Three Mile Island Nuclear Station, Unit 2 (TMI-2)
License No. DPR-73
Docket No. 50-320
Reactor Containment Building Atmosphere Cleanup

Enclosed are the responses to the 33 questions raised in your letter of December 18, 1979. If you need further explanation of these responses to complete your Environmental Assessment, please contact Mr. Ed Fuller at (201) 263-6331. We would be pleased to meet with you to discuss our responses if that would expedite the NRC review and approval of our requests to proceed with purging the TMI-2 Reactor Building.

HP-R-227 REACTOR BUILDING

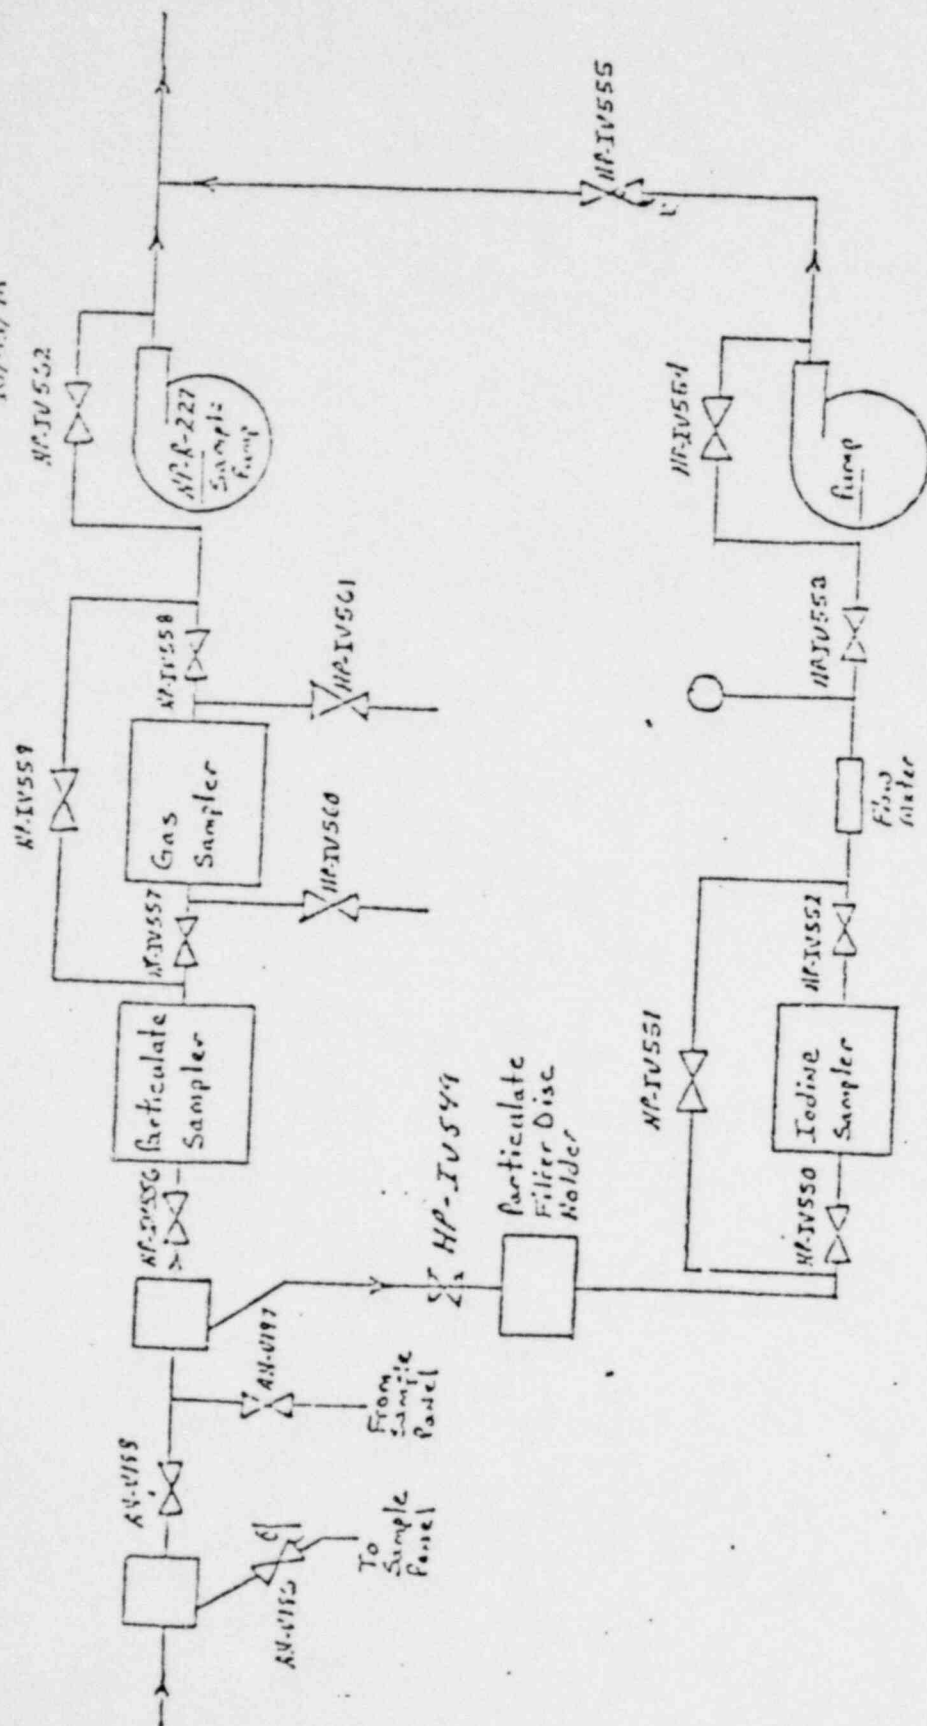
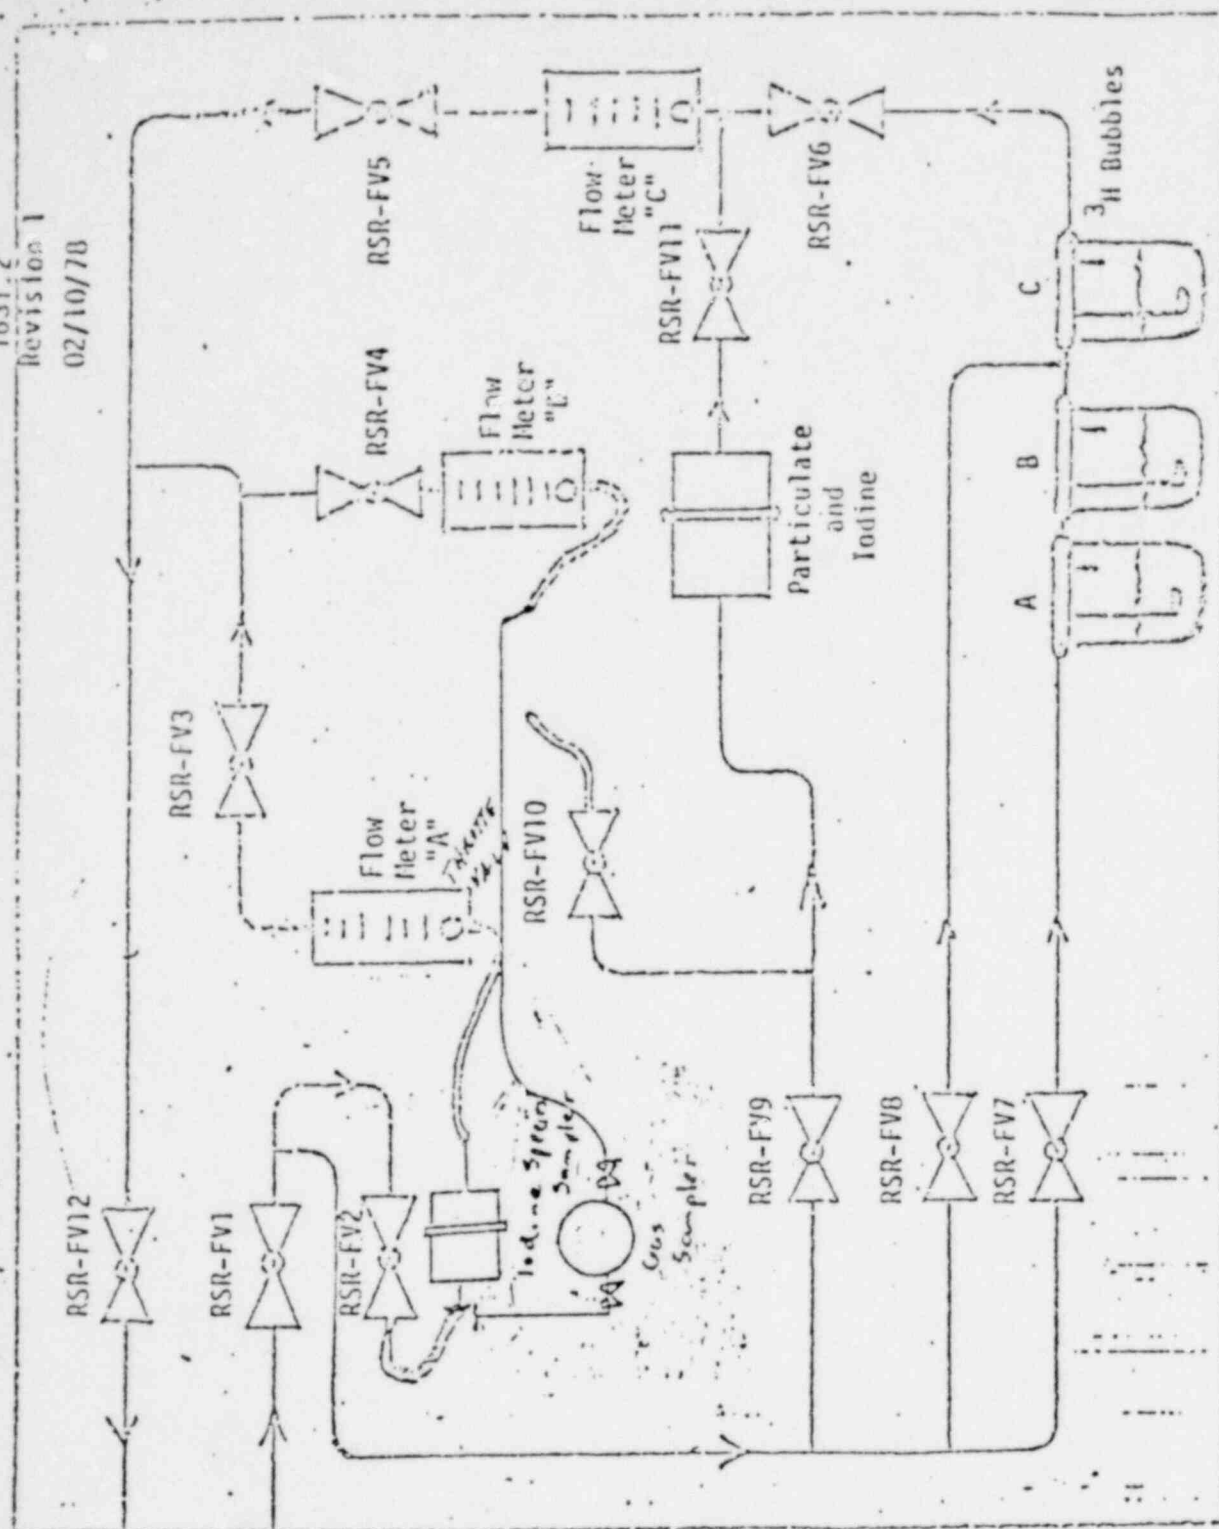
Provide a description of the radiation monitor.

HP-R-227 is a sample panel, not a radiation monitor, which allows direct sampling of the reactor building atmosphere. The sample panel can be used to fill a sample bomb for gas analysis, to perform a particulate analysis by drawing containment air through a filter, or to perform a tritium analysis by using the installed bubbler. The attached system sketches provide details of the sample system.

FIGURE 10. CALCULATED VERSUS EXPERIMENTAL BREAKTHROUGH CURVES

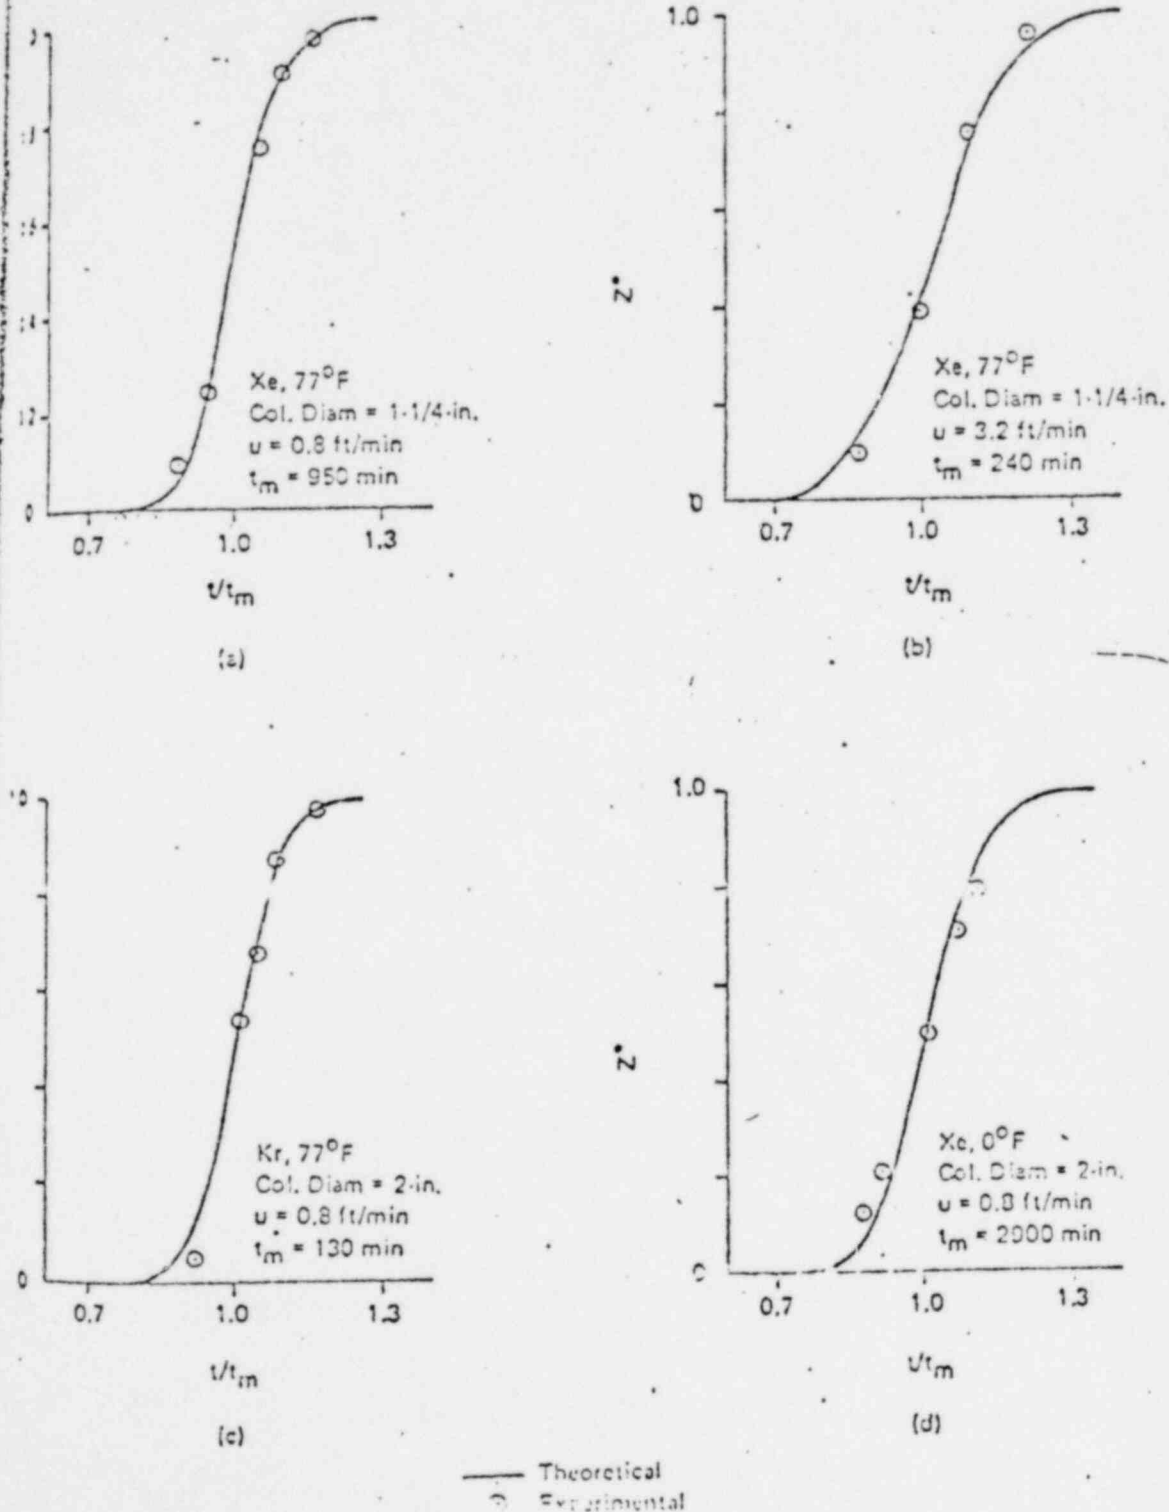
Provide the basis for the 34,000 tons of charcoal stated in this section. Provide justification as to why it is necessary to design and construct the tanks to Section III, Class 3.

Sufficient charcoal is required for processing 23×10^6 cubic feet of containment gas without the occurrence of "break-through," i.e., without detecting significant Krypton-85 at the exit of the charcoal beds.

From the 12th AEC Air Cleaning Conference, NEDO-12327, "Measurement of Dynamic Adsorption Coefficients for Noble Gases on Activated Carbon," D. P. Siegwarth, et. al., break-through occurs at some fraction of the mean residence time, t_m , of krypton in a charcoal bed. This is illustrated in enclosed Figure 10 from NEDO-12327, which shows the ratio of bed output activity to bed input activity as a function of time, given in dimensionless units of t/t_m .

From Figure 10 of NEDO-12327, the time to "break-through," t_b , is on the order of $0.7 t_m$.

Using a minimal amount of conservatism, let $t_b = 0.65 t_m$:

PRELIMINARY SCHEDULE

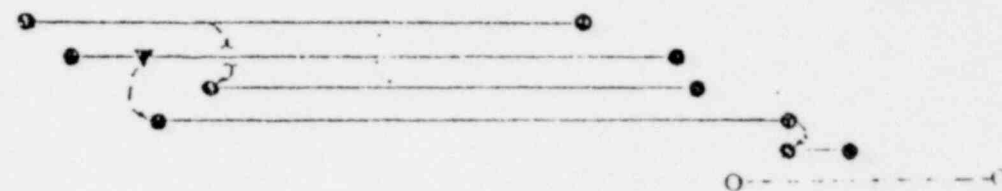
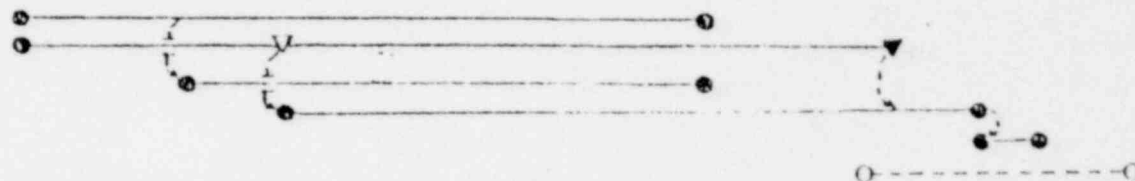
Provide a detail breakdown to justify why it will take 30 to 40 months to design and construct this system.

In order to evaluate the effort required to place the alternate systems into operation, Metropolitan Edison performed a scoping evaluation which included a preliminary system design for each alternate. These preliminary systems were then evaluated by Metropolitan Edison's architect engineer to determine schedule and costs for implementing the systems. The schedule determined is as shown in the attached bar chart. Our architect engineer used standard industry estimating and scheduling techniques to determine the times and costs presented. The cost and schedule estimates are based on years of experience and considered judgement and are considered adequate for use by Metropolitan Edison. A more detailed estimate would require greater design detail, which would impose additional, unwarranted delays in solving the Krypton-85 problem.

In order to complete the cost and schedule estimates, the architect engineer assumed as a base (or most probable) case that the buildings, equipment, piping, supports, and electrical service were seismic Category I and that the piping design code was ASME Section III, Division I, Class 3. The reasons for these assumptions are presented in the answer to Question 25. Additionally, shortest schedule/least cost and longest schedule/maximum cost estimates were also made. For the shortest schedule evaluation, buildings, equipment, piping, supports, and electrical service were non-seismic, and the piping design code was ANSI B-31.1/ASME VIII. For the longest schedule evaluation, the same seismic and code requirements as used for the most probable case were used, but aircraft hardening for the building was also assumed. In each case, the schedules and costs are considered to be the additional time/cost required for the alternates as compared to the base case of performing a controlled vent of the containment.
